SUNDRY NOTICES AND REPORTS ON WELLS

Florance AB 4

PLUG AND ABANDONMENT PROCEDURE

Florance AB #4

Proposed P&A

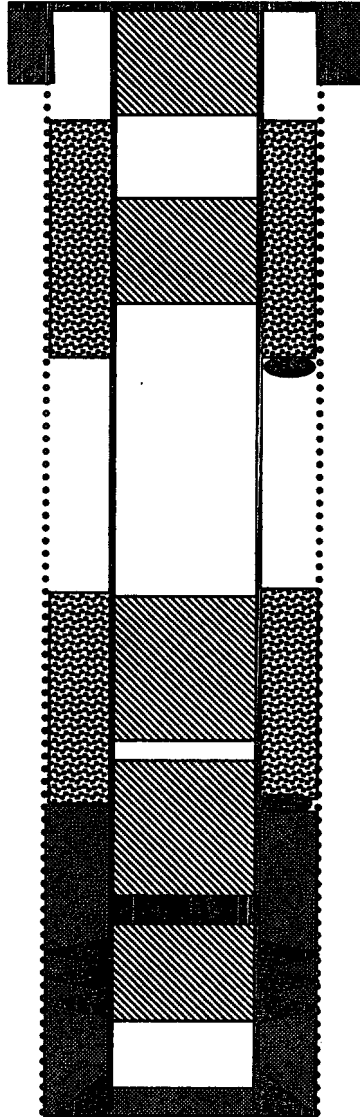
5. **Plug #2 (Kirtland and Ojo Alamo tops, ~~2159' – 2010'~~):** Mix ~~21~~ sxs Type III cement and spot a plug inside the casing to cover the Kirtland and Ojo Alamo tops. PUH to 820'.
669' 569'

6. **Plug #3 (Nacimiento top, ~~820' – 720'~~):** Mix 16 sxs Type III cement and spot a plug inside the casing to cover the Nacimiento top. PUH to 306'.
